TOWN HALL RENOVATIONS - ADDENDUM 01

Project: BERLIN TOWN HALL & ANNEX RENOVATIONS

Project No.: 2024-41

Date: DECEMBER 17, 2025

**LEVEL 01
DEMOLITION
UNDER FLOOR
PLAN - PLUMBING**

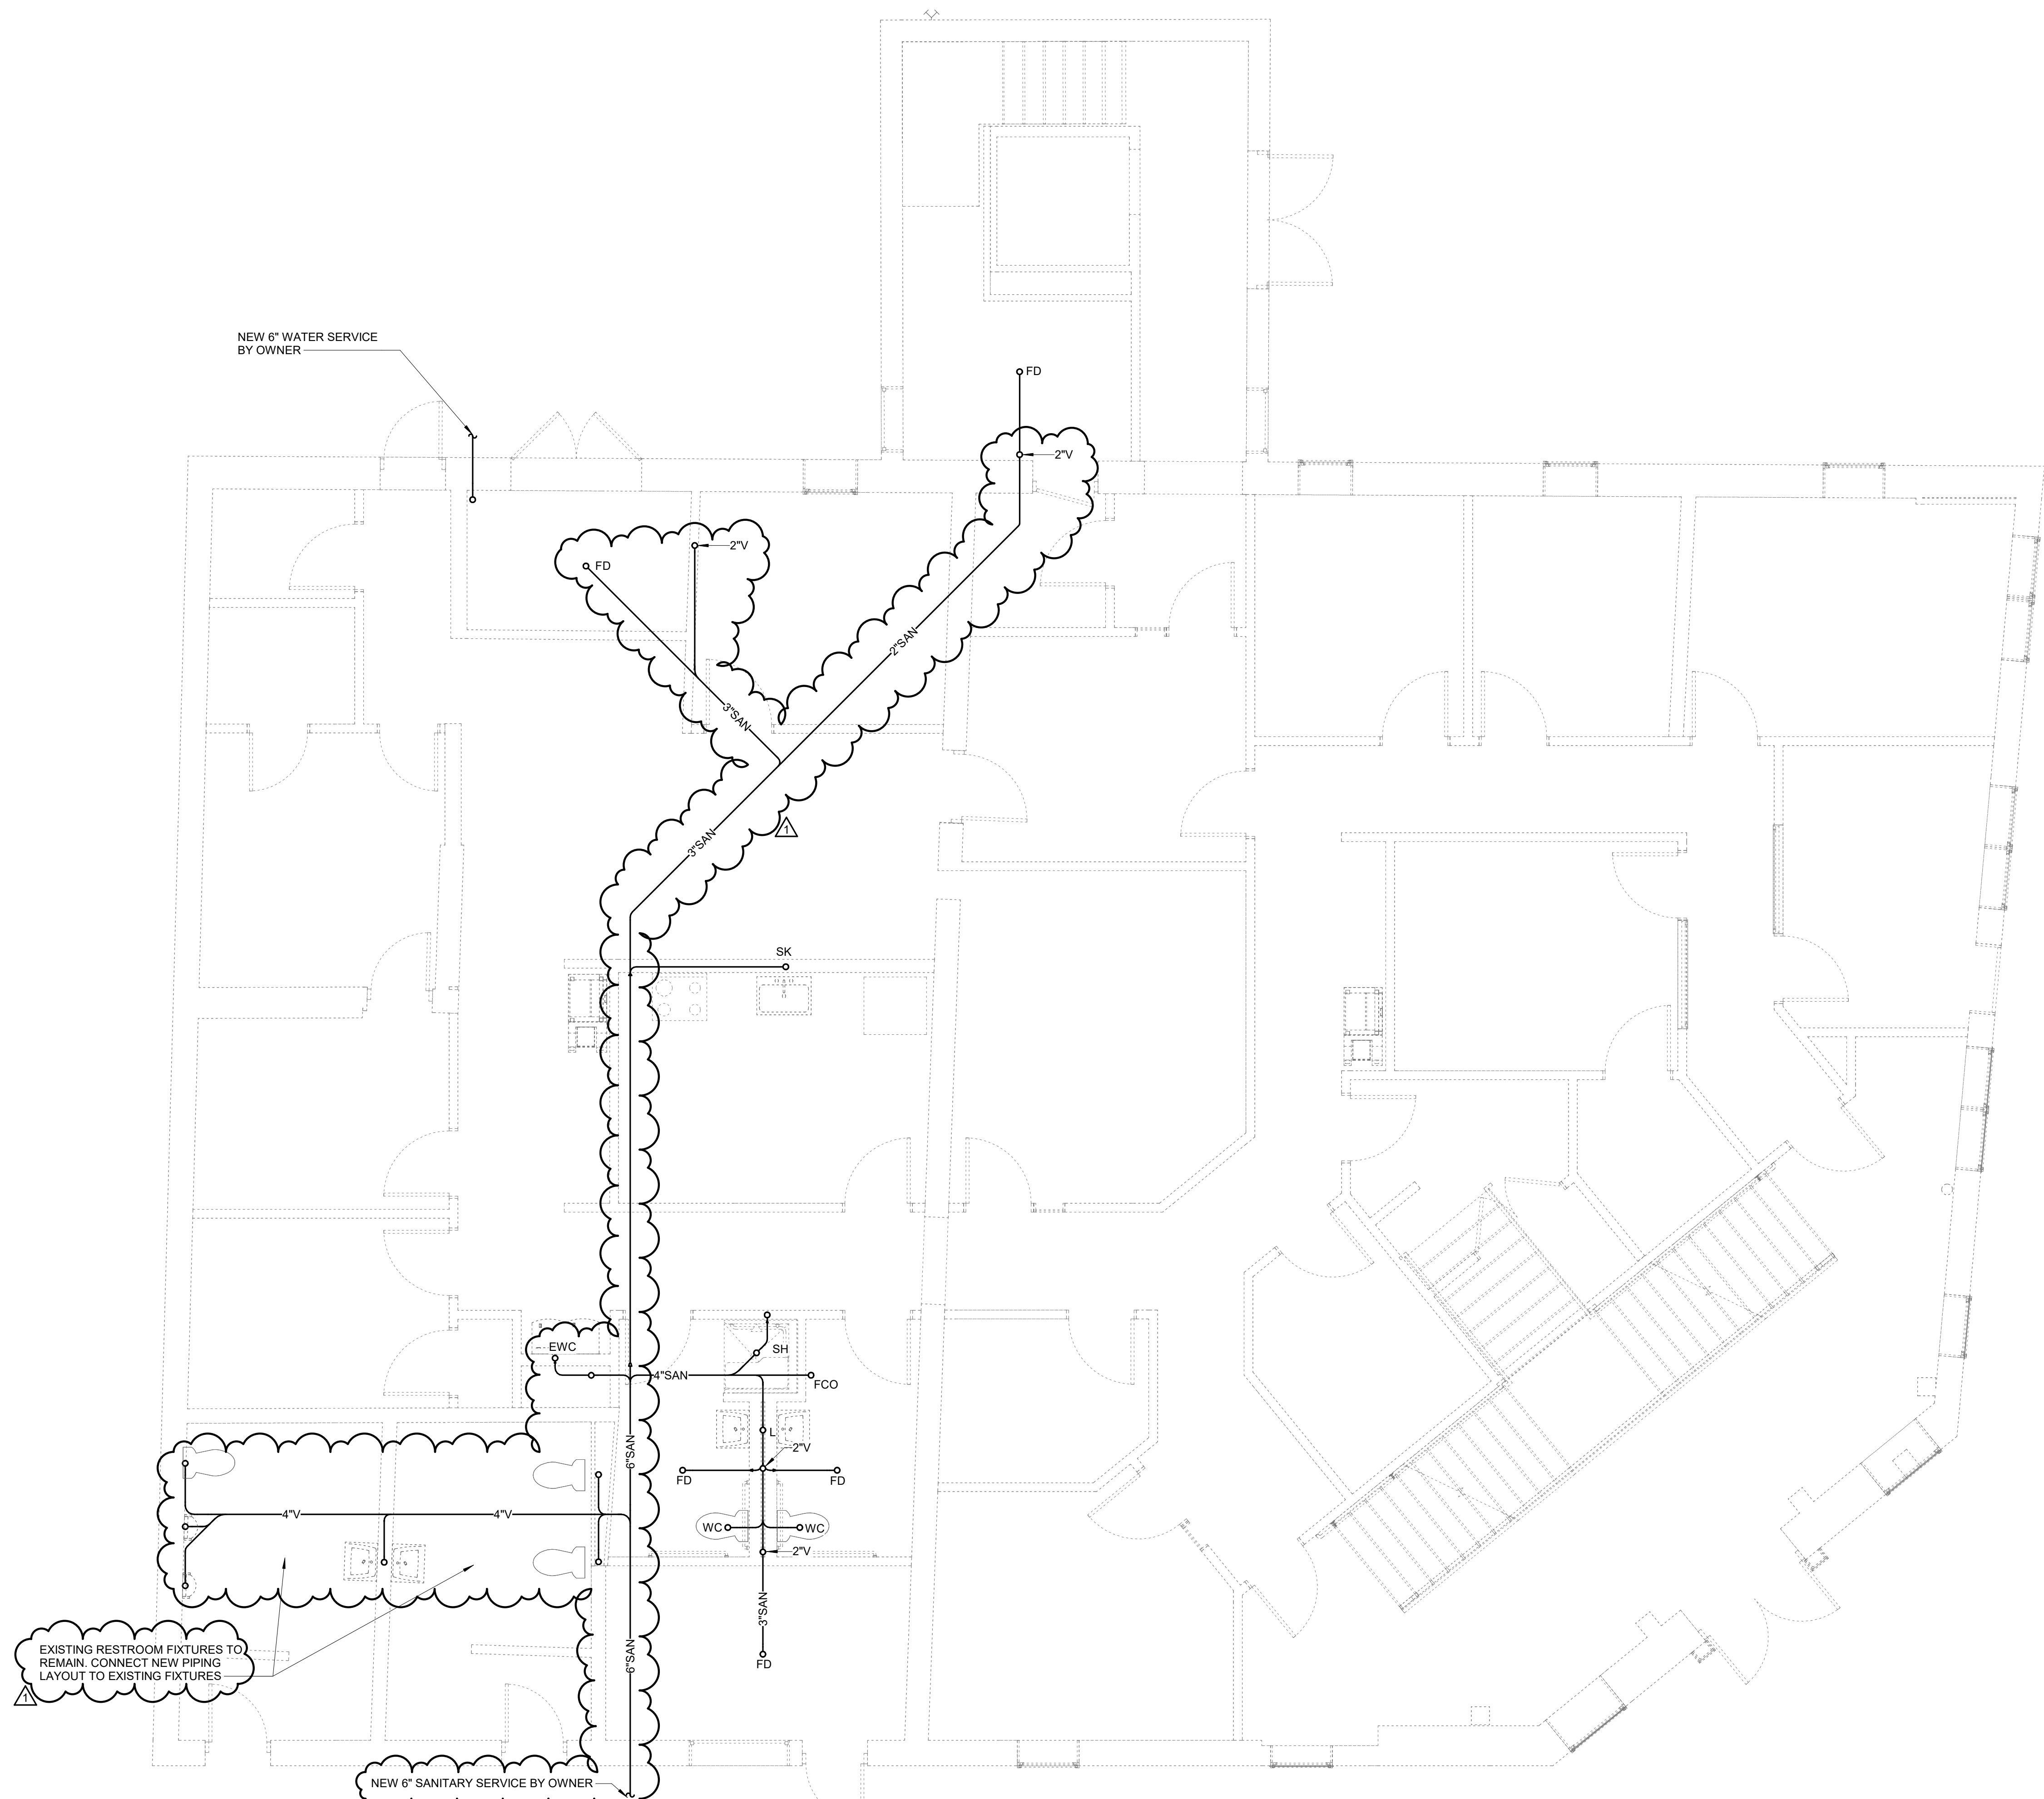
Sheet No.	Description of Revision
I-501	ADD DETAIL 7 – EXISTING STAIRS 133 – REFINISH DETAIL (ATTACHED)
I-601	DELETE NOTE FOR ADD/ALT. MURAL ON ROOM 220 STAIR TOWER
I-602	UPDATE STAIR PARTS SCHEDULE (ATTACHED)
P100	UPDATED PLUMBING UNDER FLOOR DEMOLITION PLAN (ATTACHED)
P101	DELETE GENERAL NOTE 1 IN ITS ENTIRETY
P102	ADD KEYNOTE 2. VIF LOCATION OF EXISTING VENT THROUGH ROOF AND REMOVE. PATCH ROOF PENETRATION.
P200	UPDATED PLUMBING UNDER FLOOR PLAN (ATTACHED)
P201	UPDATED LEVEL 01 PLUMBING PLAN (ATTACHED)
P500	UPDATED PLUMBING DIAGRAMS (ATTACHED)
P600	UPDATED PLUMBING SCHEDULES (ATTACHED)

17. **QUESTION:** Specification Section 013516-4 Item 3.1.E Protection – Existing Drains states that “prior to the start of work in an area, test drainage system to ensure that it is functioning properly. Notify Architect immediately of inadequate drainage or blockage. Do not begin work in an area until the drainage system is functioning properly”. But Drawings P100, P101, P200 and P201 General Notes 1. states “Condition and layout of existing below slab sanitary drainage piping is currently unknown. Scoping to determine condition and layout to be performed By Owner post bid issuance (emphasis added). Updated drawings to reflect observed layout shall be issued in Addendum”. Sounds to us like the Owner is handling the sanitary drainage viability and routing exercise, not the Contractor. Clarify who is doing drainage system testing or how this should be included in the bid.

ANSWER: EXISTING SANITARY INVESTIGATIONS HAVE BEEN COMPLETED. ALL EXISTING SANITARY PIPING TO BE REPLACED. TOWN WATER DEPARTMENT WILL BE HANDLING NEW WATER SERVICE AND NEW SANITARY SERVICE TO THE BUILDING. CONTRACTOR RESPONSIBLE FOR NEW SANITARY PIPING WITHIN THE BUILDING. BEFORE NEW SANITARY PIPING IS COVERED (BY SLAB WORK ETC.), CONTRACTOR RESPONSIBLE FOR SCOPING AND FLOW-TESTING THE PIPING AS INSTALLED. SEE UPDATED PLUMBING SHEETS.

1. LAYOUT OF EXISTING UNDERSLAB PIPING IS BASED ON SCOPING PERFORMED BY OWNER. CONTRACTOR SHALL VERIFY IN FIELD QUANTITY AND LOCATION OF SANITARY CONNECTIONS TO STREET SERVICES, CUT AND CAP ALL SANITARY SERVICES OUTSIDE THE BUILDING. ALL BELOW SLAB PIPING MAY BE ABANDONED IN PLACE, CUT AND CAP PIPES BELOW FLOOR. REPAIR BUILDING CONSTRUCTION TO MATCH ORIGINAL.

ATTN: MAYOR &
COUNCIL OF THE
TOWN OF BERLIN 10
WILLIAMS ST .
BERLIN, MD 21811
**PLUMBING
DIAGRAMS**

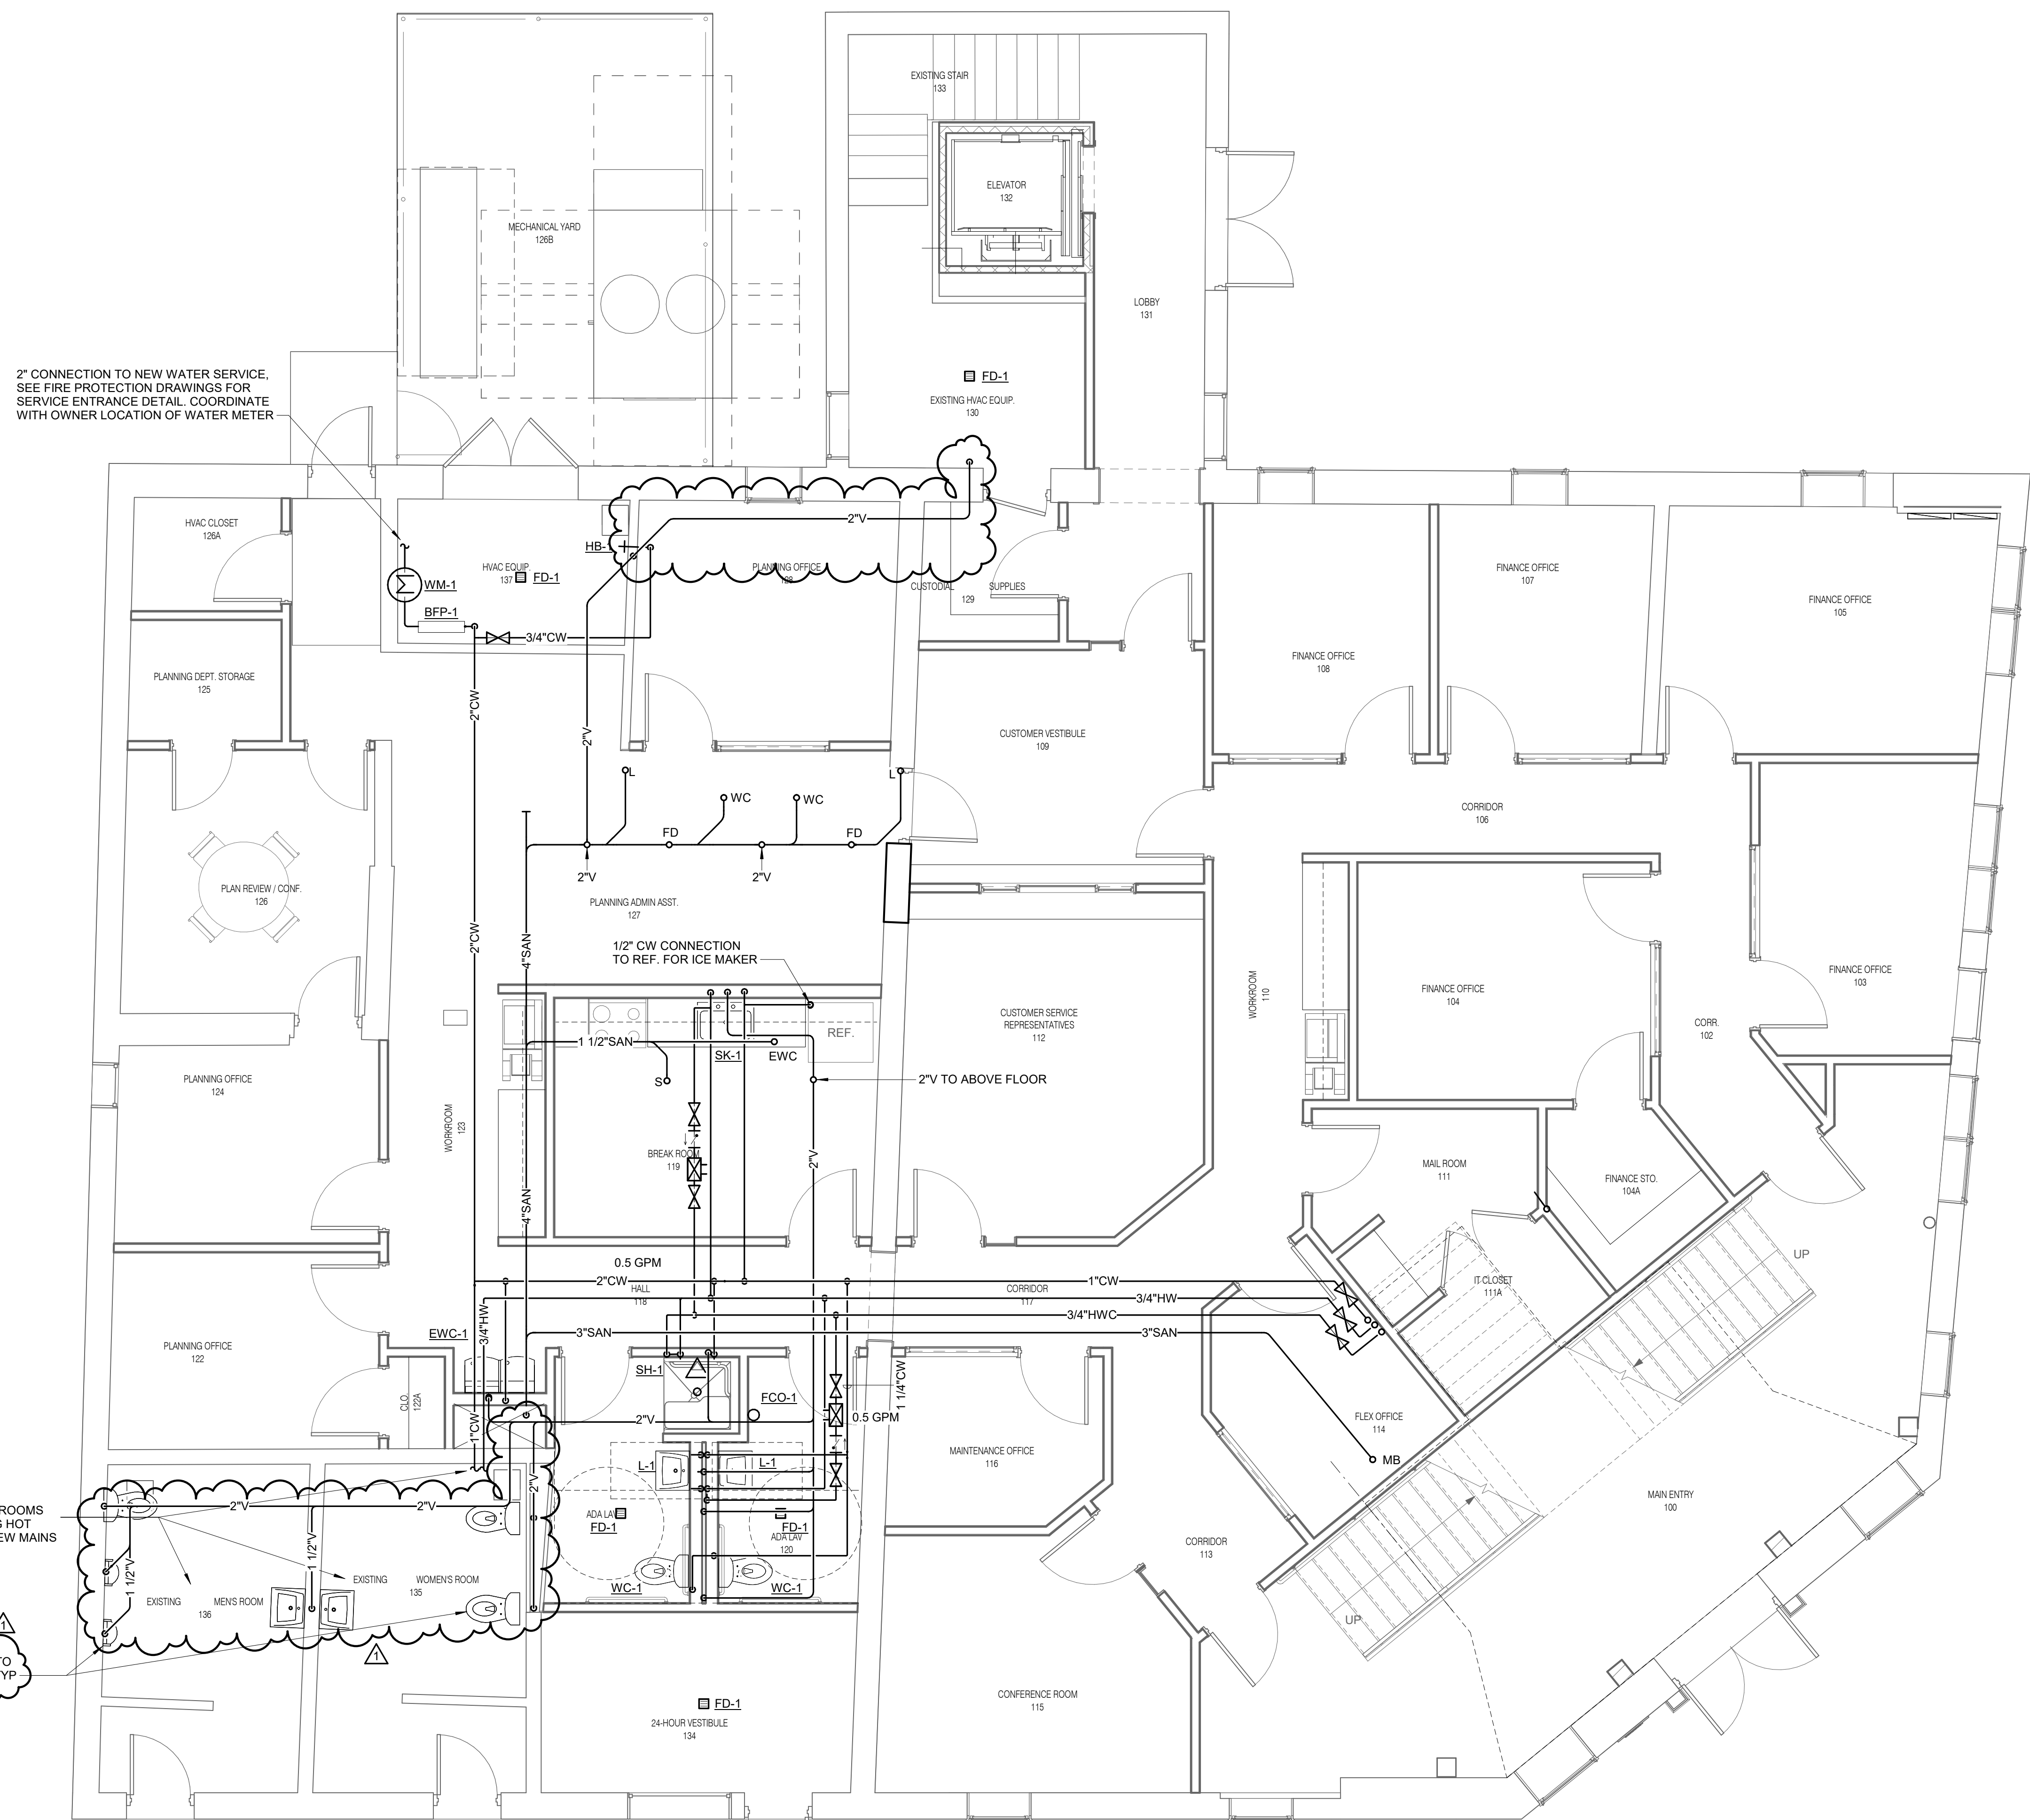
20. **QUESTION:** Drawing P-201 shows a HB-1 fixture designation for a hose bibb. This designation is not shown on the plumbing domestic water riser diagram on Drawing P-500. Please advise as to whether we are to include this in our bid.

ANSWER: YES THE HOSE BIBB IS WITHIN THE PROJECT SCOPE. SEE UPDATED PLUMBING SHEETS.
